SERVICE BULLETIN 99 MANDATORY

SUBJECT: LANDING GEAR ELECTRICAL SYSTEM WIRING CHANGE

APPLICATION: All Glasair III Aircraft constructed before publication of Revision H of the Instruction Manuals (to be published 7/01/91).

LANDING GEAR
ELECTRICAL SYSTEM SCHEMATIC
(REVISED)

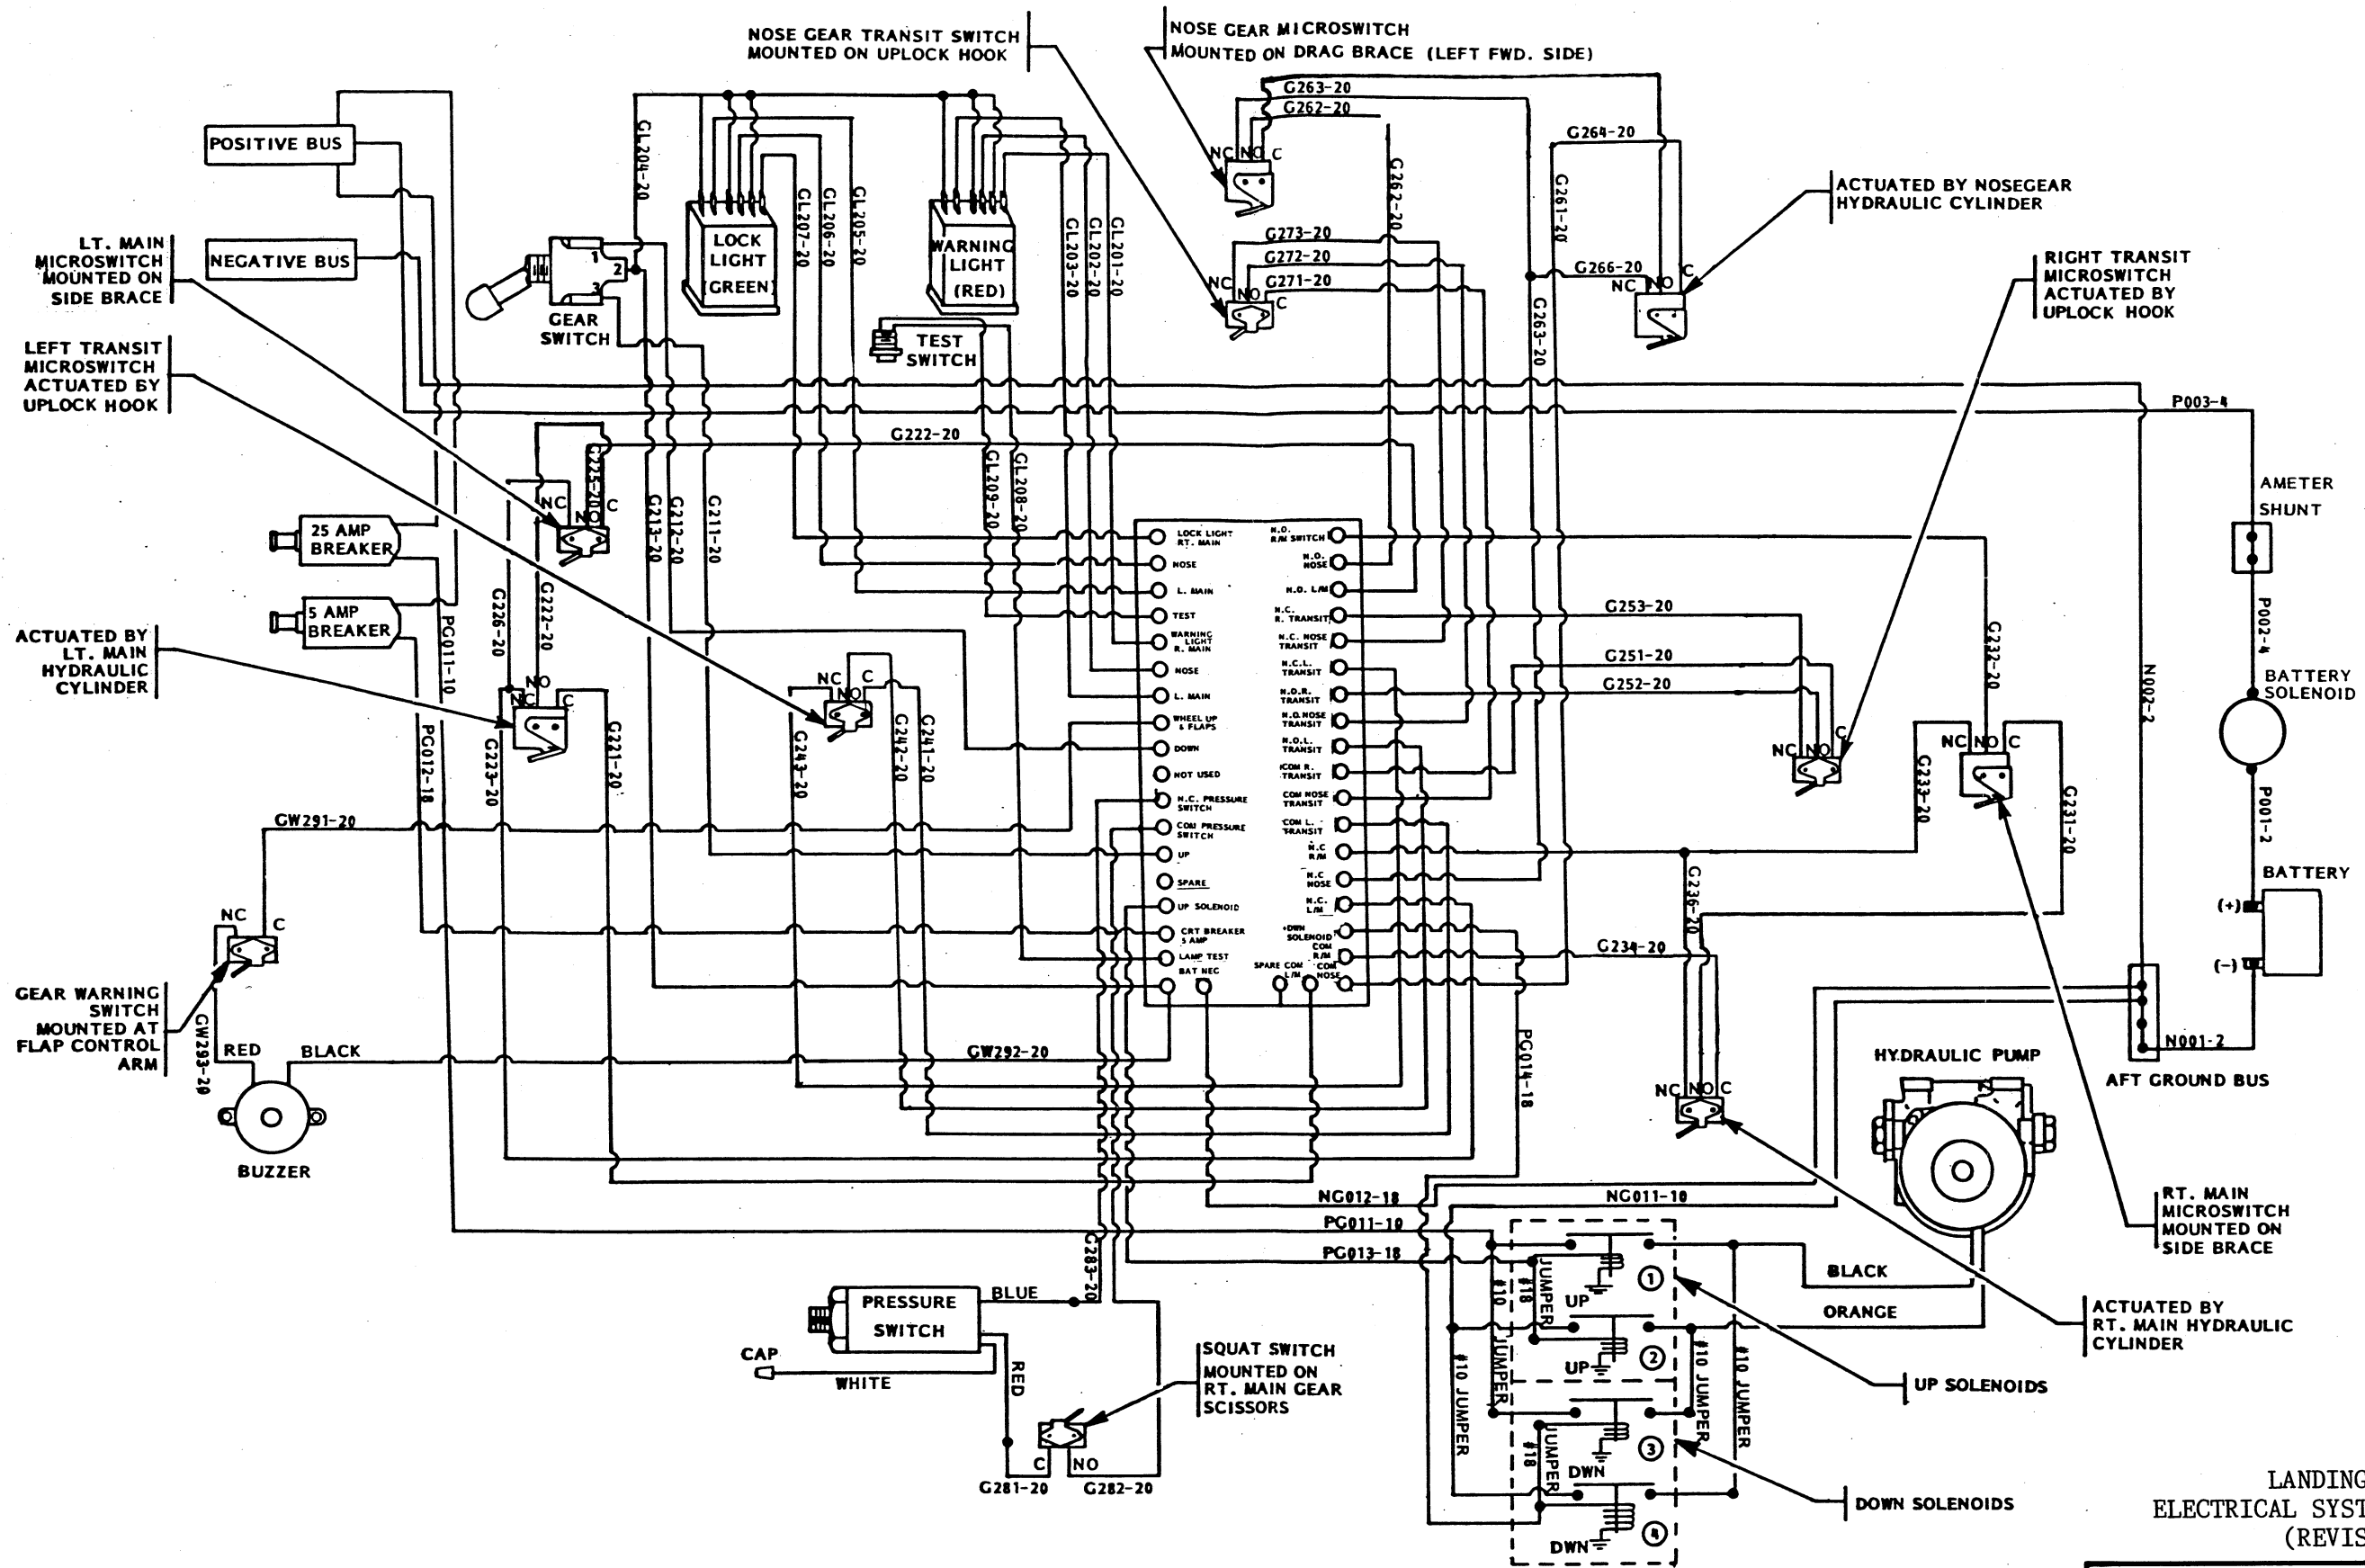
DESCRIPTION: In the landing gear electrical system as described in the Instruction Manuals, all three terminals of the side brace (or drag brace) microswitch are wired in parallel with the corresponding terminals of the hydraulic actuator microswitch for each gear strut. (Refer to the wiring schematics on pages G-277 and G-306.) The service history of this wiring has exposed a couple of problems. First, for part of the landing gear extension and retraction cycles, when one of the two switches for the gear strut has actuated but the other hasn't, both the green and the red light for that strut will be on simultaneously. This is more confusing than dangerous, although the ambiguous indication could complicate trouble-shooting a gear problem during flight. Also, when troubleshooting a misadjusted downlock microswitch, since the NO (normally open) sides of the side brace and hydraulic actuator microswitches are in parallel, all three green lights will remain on along with all of the red lights and the pump, therefore not giving a clear indication of which strut has the misadjusted switch. A second, potentially more serious problem could occur if a connection to the COM (common) terminal of one of the switches were to fail. In this case (as happened on our prototype), there would be a green light, indicating gear down, and the hydraulic pump would shut off prematurely, not completing the gear extension cycle to achieve down pressure. (Fortunately, we were able to land normally, avoiding a costly repair.) Remember to always check for adequate gear down pressure at the gauge when landing.

SOLUTION: We have revised the landing gear electrical system to connect the COM (common) and NO (normally open) terminals of the hydraulic actuator and side or drag brace microswitches of each gear strut in series, and the NC (normally closed) terminals in parallel, as shown in the accompanying revised landing gear electrical system wiring schematic. With this wiring system, the green light for each strut will remain off until both switches in the series circuit have been actuated; then the green light will illuminate. Also, with this system, if a connection to the COM terminal of one of the switches were to fail, a green light would not illuminate after the pump and the red transit light turned off. In this case, the pilot would be aware of a possible problem and should request visual confirmation of gear extension from a person on the ground or from another aircraft in flight. (On our prototype we mounted a small convex mirror on the left wing tip to visually verify gear extension; see the picture in Newsletter #36, page 450.) Alerted to a possible problem, the pilot should also verify adequate pressure in the extension system by consulting the pressure gauge and could use the hand pump to build pressure, if necessary.

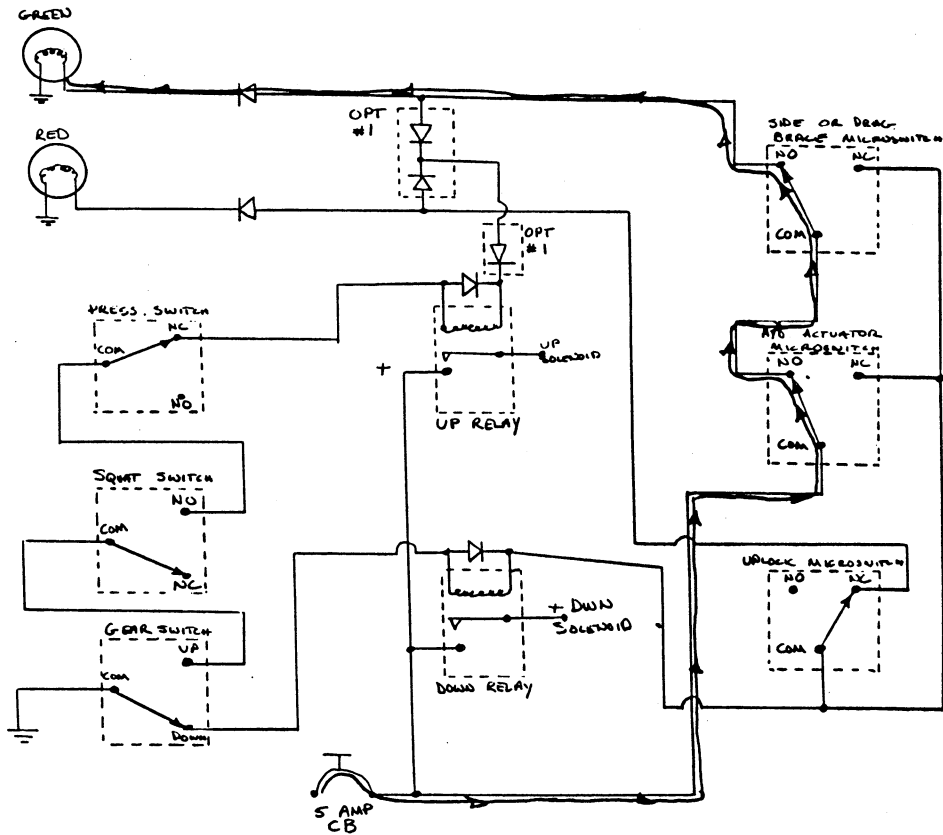
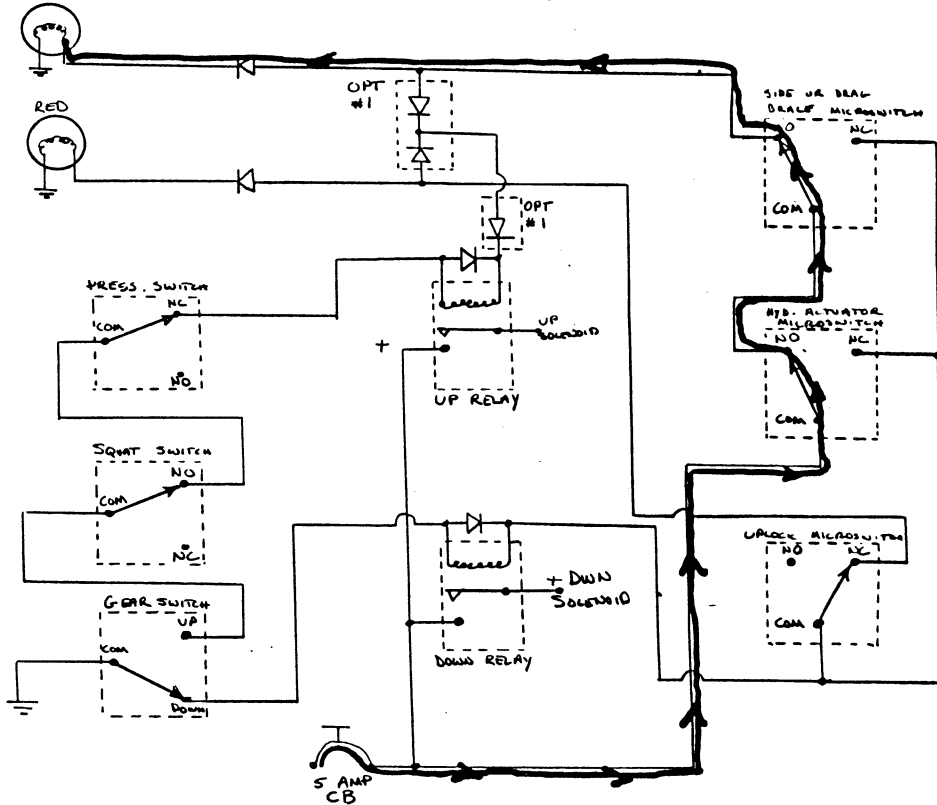
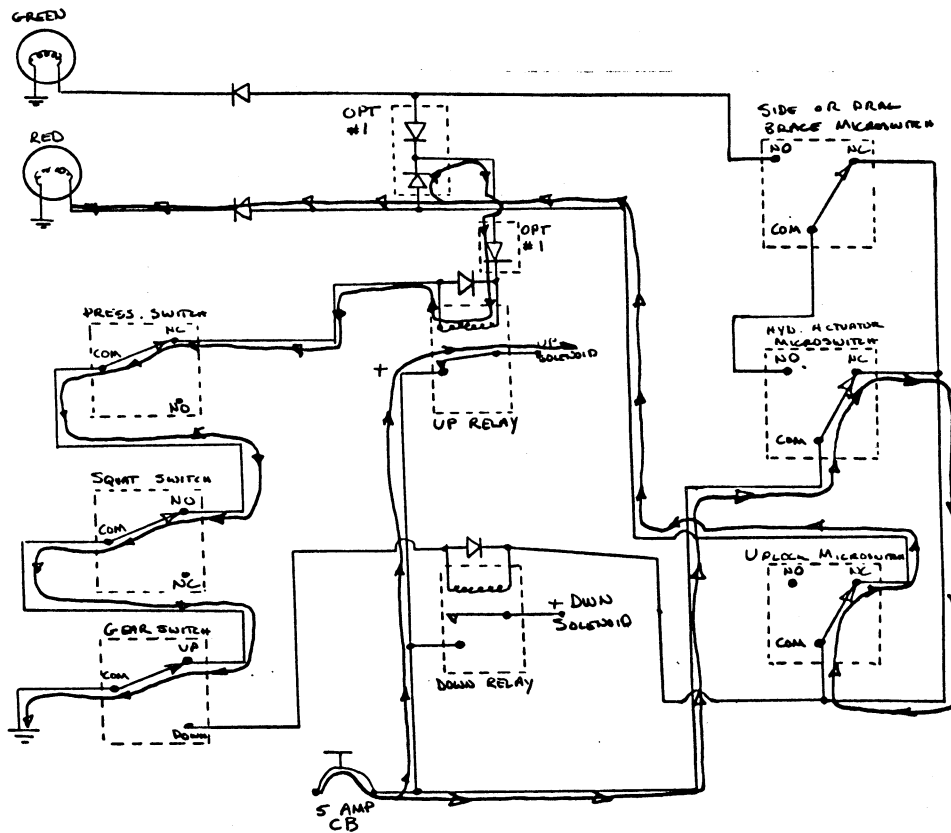
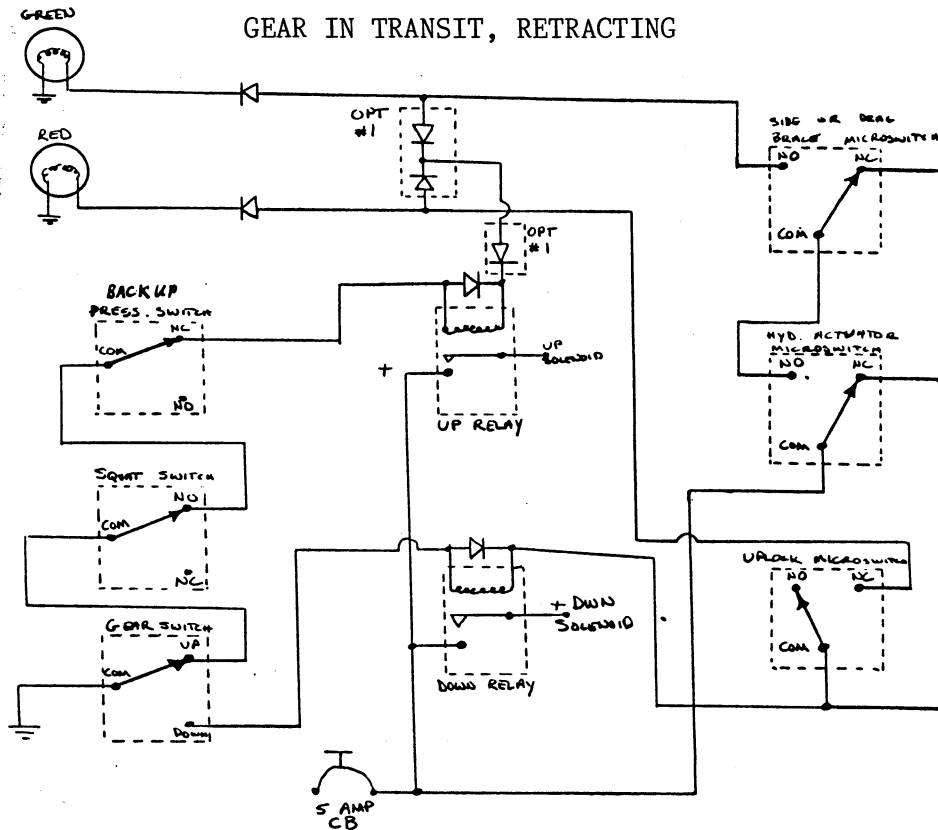
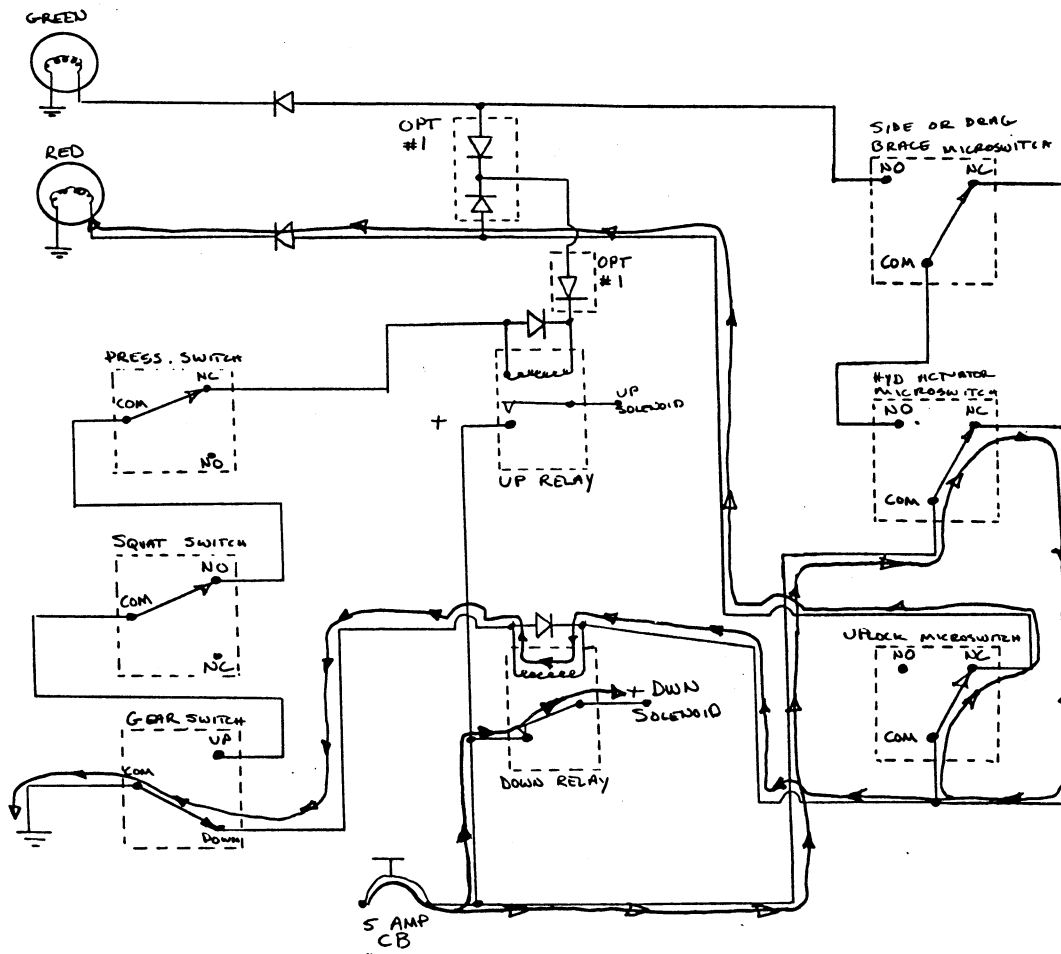
Also included with this service bulletin are simplified schematics showing the positions of the various switches in the circuit for one gear strut during different phases of the landing gear extension and retraction cycles; similar circuits exist for each of the other two struts and all three circuits are wired in parallel to the UP and DOWN relays on the PC board. These schematics are supplied for your use in trouble-shooting landing gear electrical system problems. Study the enclosed complete electrical system schematic and the PC board schematic on page G-306 of the Instruction Manuals to enhance your understanding of these trouble-shooting schematics. If a 3-wire pump is used, refer to figure (H-22) on page H-39 of the Appendices section.
